FIRE SAFETY INSPECTION REPORT

AKH KNITTING & DYEING LTD.

ACCORD ID: 9210

SUMMARY

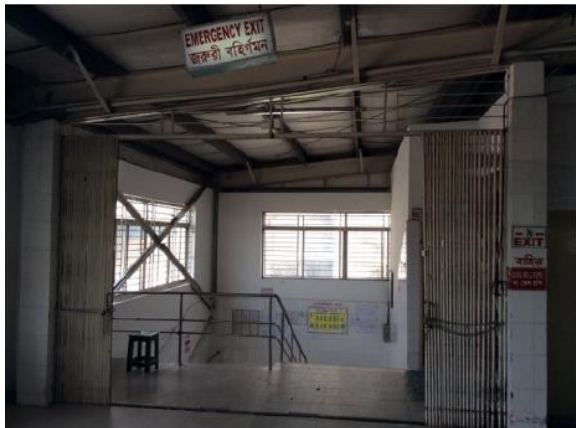
No.	Category	Finding	Recommendation	Remediation Timeframe
F-1	Fire Rated Construction	Diesel fuel storage was located inside the generator room.	Remove all diesel fuel storage from the generator room and relocate to the exterior such that the diesel fuel storage is at least 10 ft. from required egress paths. If located along egress paths or in a utility building, provide the diesel fuel storage with 2-hr fire rated construction. There shall be no diesel fuel storage in a factory production building.	Immediately
F-2	Fire Rated Construction	The boiler room is not separated by fire-rated construction due to (openings, non-rated doors, penetrations). The boilers are located in building 2, which is in between Building 1 to its east and Building 3 to its west.	Separate the boiler room by a minimum 1-hr fire rated construction for non-high rise. Seal and/or protect all openings to maintain the required fire separations. When located to the exterior of a building, 3m (10 ft.) separation is required. Provide proper ventilation and consult a qualified engineer.	Within 3 months

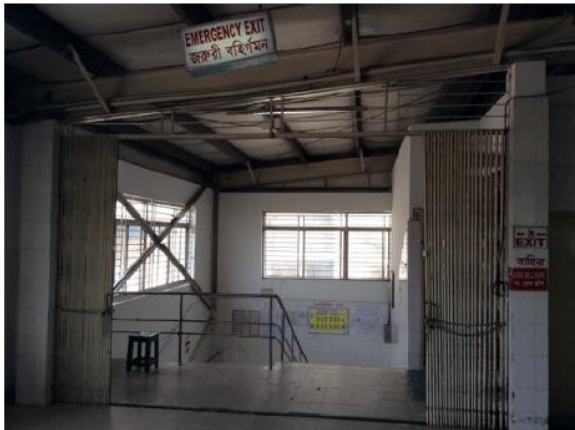
F-12	Egress	Handrails are not provided on both sides of the exit stairs.	Provide handrails on both sides of the exit stairs. New handrails shall have a minimum height of 865 mm (34 in.) and a maximum height of 965 mm (38 in.) as measured from the leading edge of the tread. Intermediate handrails shall be provided when the stair width exceeds 2.2 m (87 in.)	Within 3 months
------	--------	--	---	-----------------

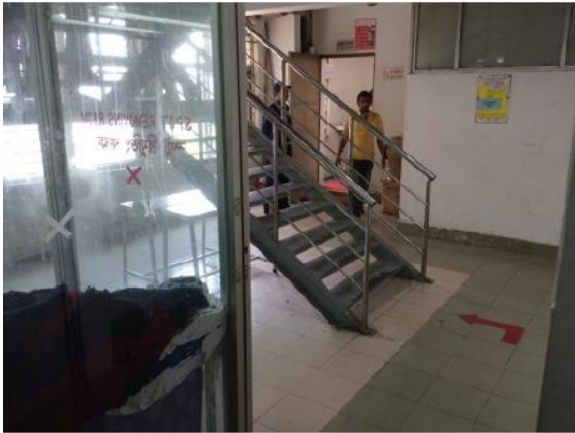
F-11	Egress	Exit stairs discharge inside the building.	Modify stair to discharge directly outside. Or provide 2-hr fire-rated exit passageway leading directly outside (vestibules to separate any storage areas).	Within 6 months
------	--------	--	---	-----------------

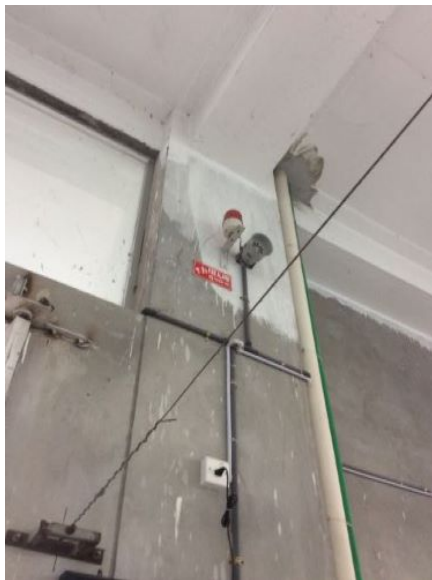
F-22	Fire Protection	Visible notification was not provided for the building in accordance with NFPA 72.	Provide visible notification for the building in accordance with NFPA 72.	Within 3 months
------	-----------------	--	---	-----------------
